STATE OF NORTH CAROLINA  
DEPARTMENT OF TRANSPORTATION

SUBJECT: **Request for Modification to the Section 404 Individual Permit and Section 401 Water Quality Certification** for the proposed Winston-Salem Northern Beltway Eastern Section from US 158 to I-40 Bus/US 421, Forsyth County, Division 9. WBS Element No. 34839.1.2, TIP No. U-2579B.

REFERENCE: USACE Individual Permit Action ID SAW-2008-03183, dated June 2, 2014.  
NCDWR Project No. 2014-0090, Certification No. 3987, dated April 11, 2014.

PERMIT DRAWING  
SHEET 38 OF 64

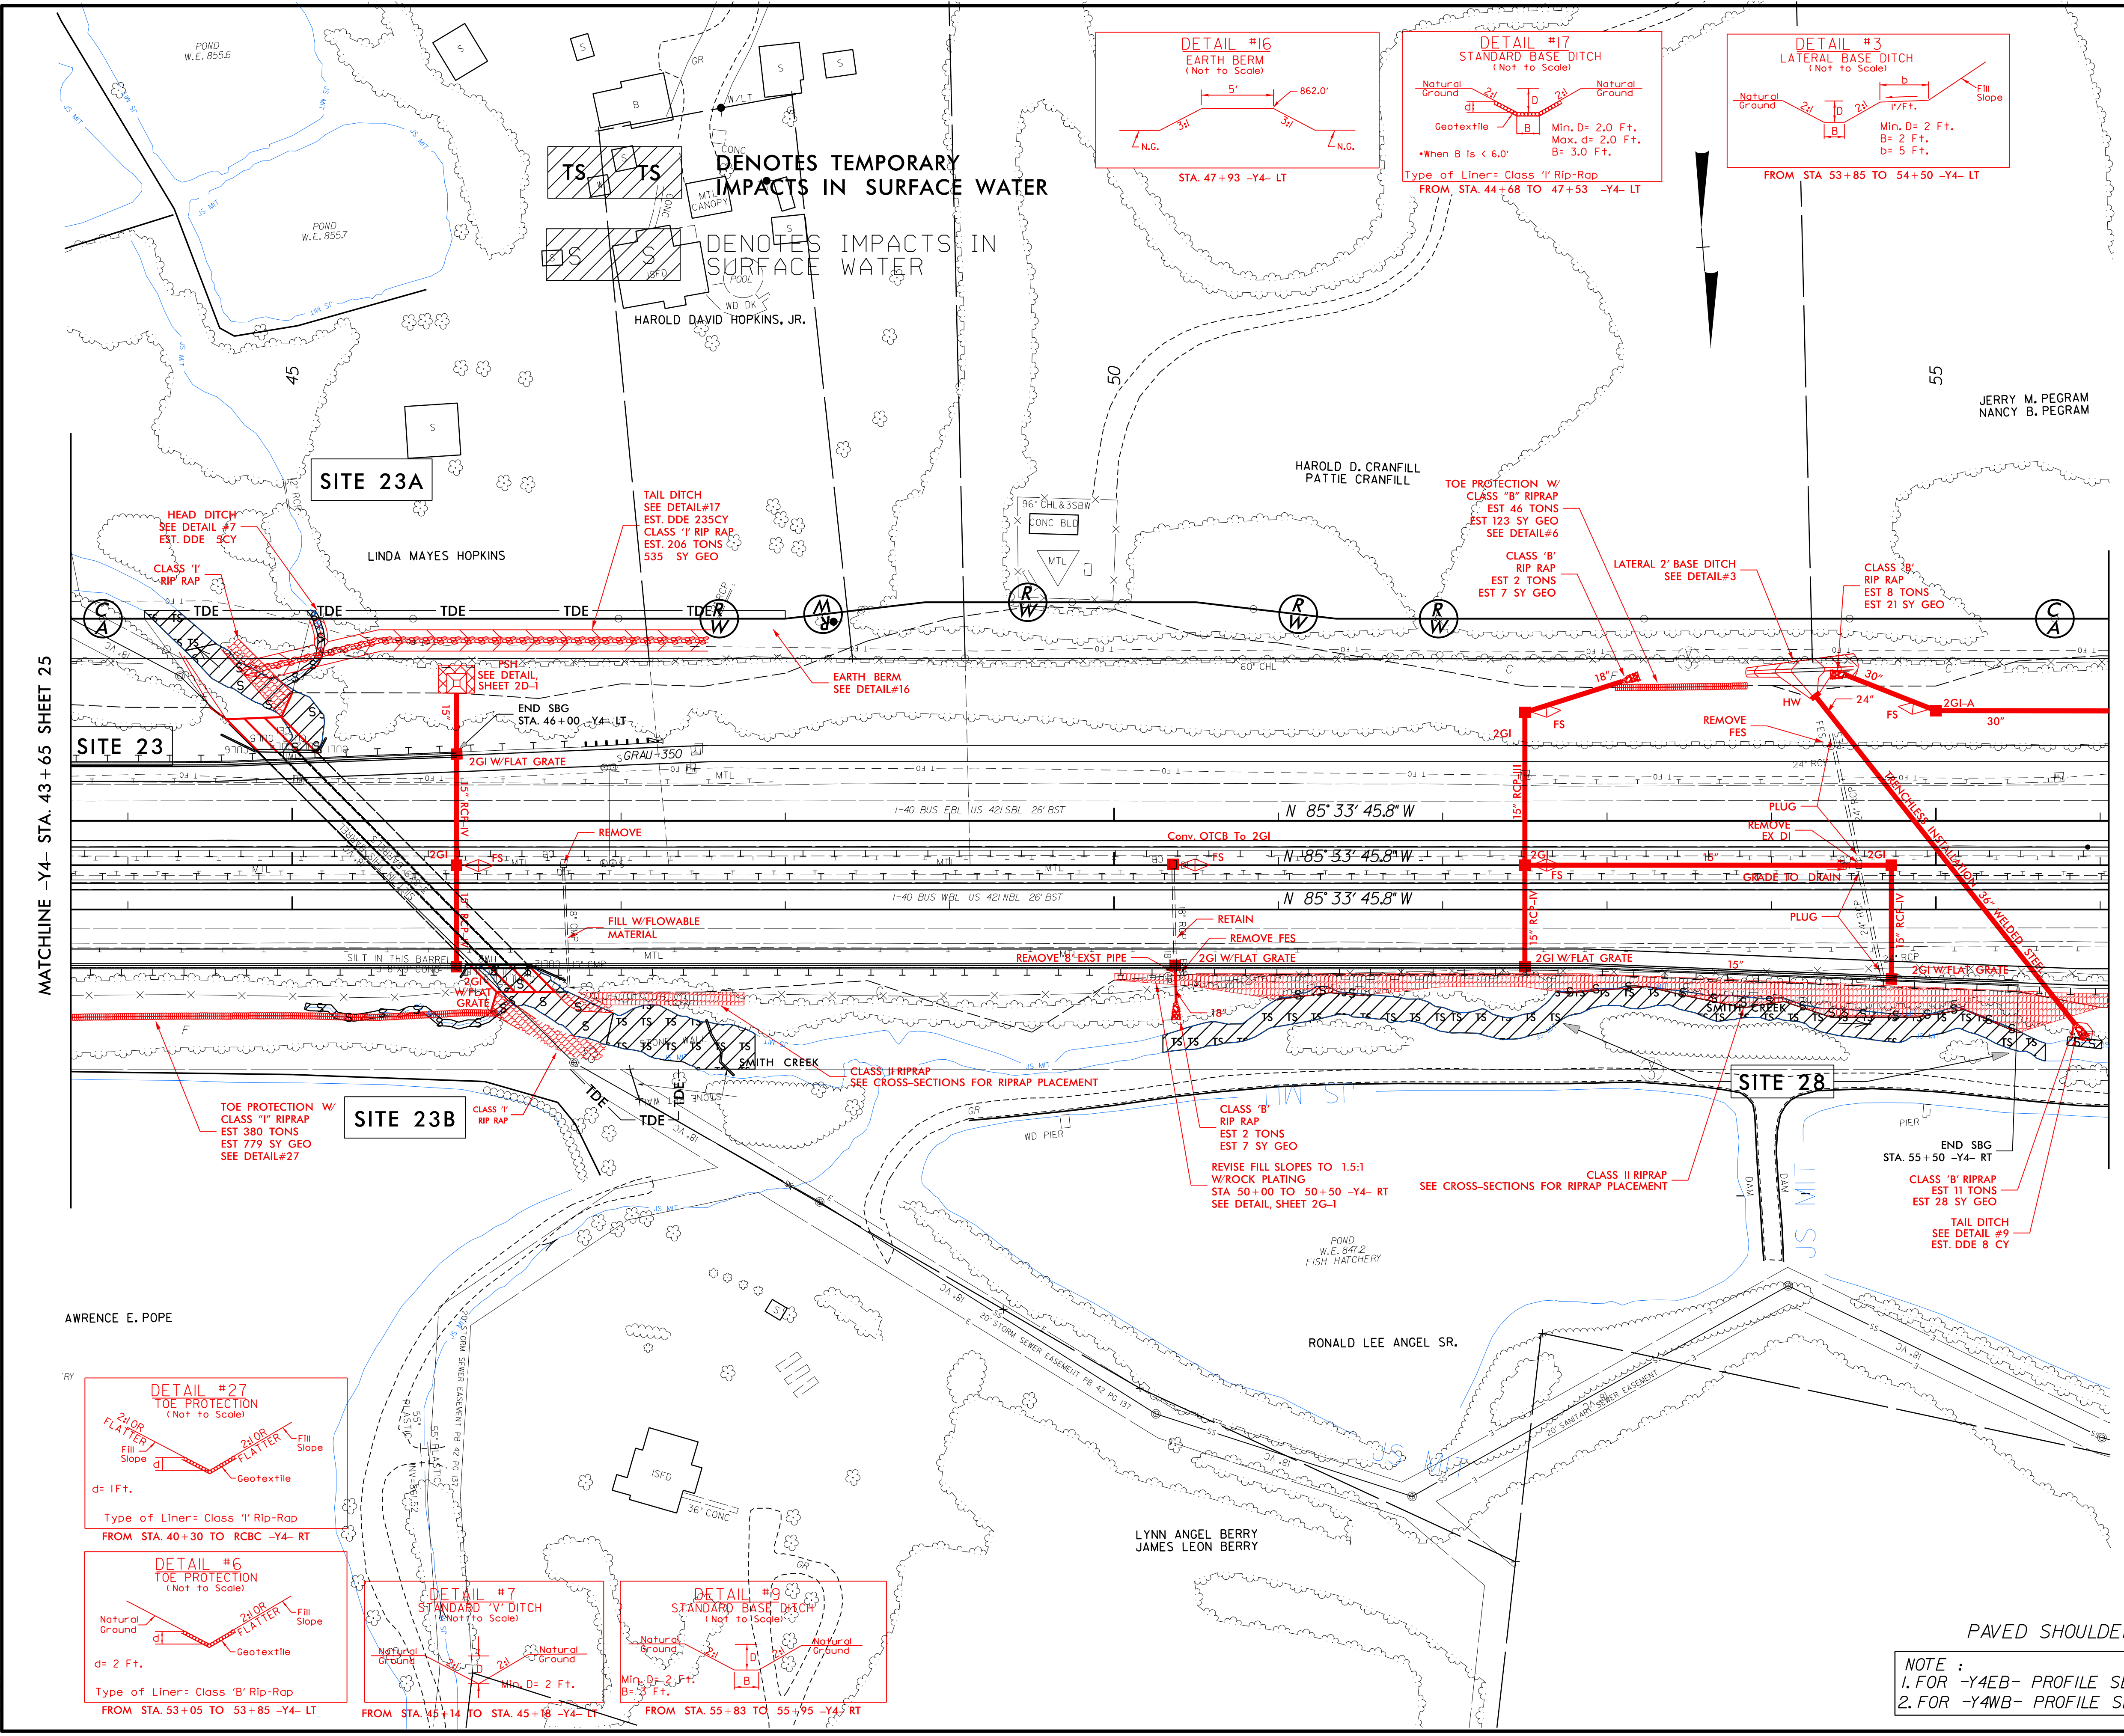
The purpose of this letter is to request a modification to the United States Army Corps of Engineers (USACE) Individual Permit and North Carolina Division of Water Resources Certification for the above referenced project. The requested modification is to account for additional bank stabilization and temporary stream impacts to the project since the approval of the above permit. It was recently determined that a retaining wall will be necessary to keep the widening of US 421 out of Smith Creek. Permit Sites 23 and 28 will be affected from this activity. Temporary stream impacts will increase from 21 linear feet to 89 linear feet for Permit Site 23. Bank stabilization for Permit Site 28 will increase from 25 linear feet to 365 linear feet and associated temporary impacts will be 188 linear feet for Permit Site 28. These impacts are shown in the attached Revised Permit Drawing Sheets 38, 39, and 40 of 64, and in Table 1 below.

Below is the revised stream impact table (Table 1). The revised permit sites are Permit Sites 23 and 28 with revisions shown in bold and italicized. All other tables from the original permit application remain the same. The NCDWR stream mitigation requirements increased 340 linear feet due to bank stabilization, however, the mitigation requirements are still covered by the current NCEEP acceptance letter. The USACE mitigation requirements listed in the original permit still remain the same.

**PERMIT DRAWING  
SHEET 40 OF 64**

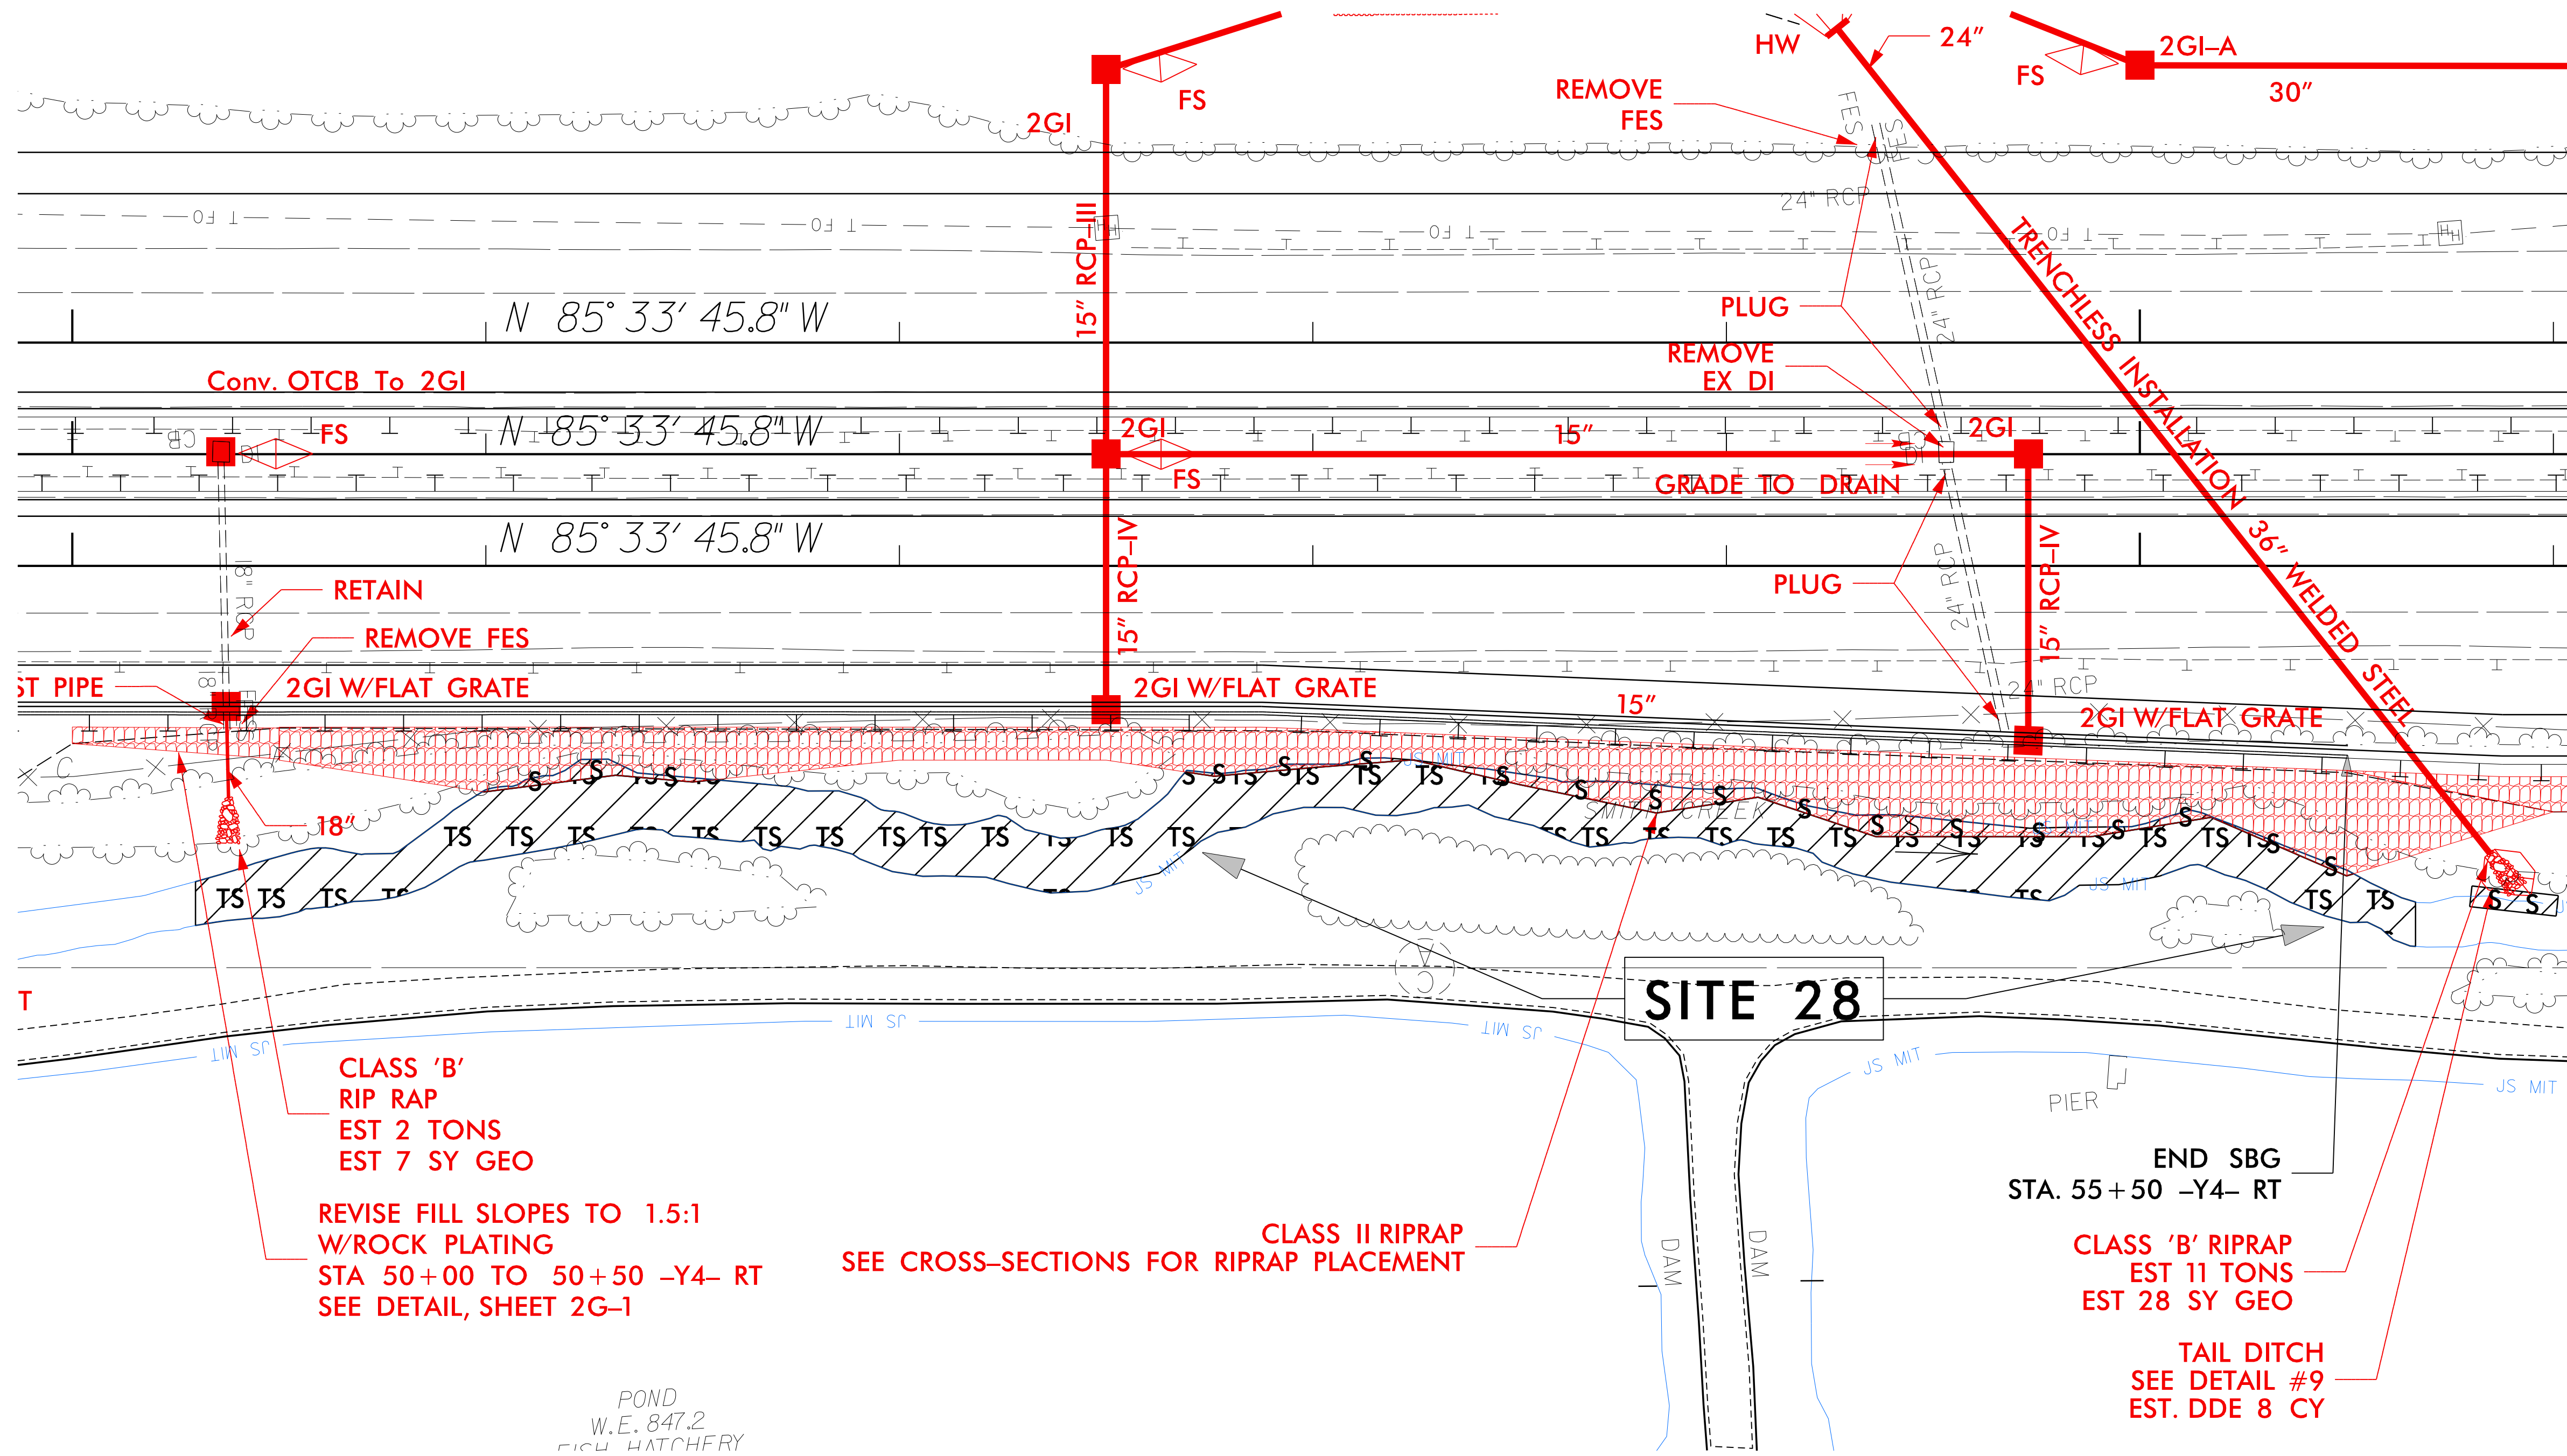
REVISE FILL SLOPES TO 1.5:1  
W/ROCK PLATING  
STA 50+00 TO 50+50 -Y4- RT  
SEE DETAIL, SHEET 2G-1
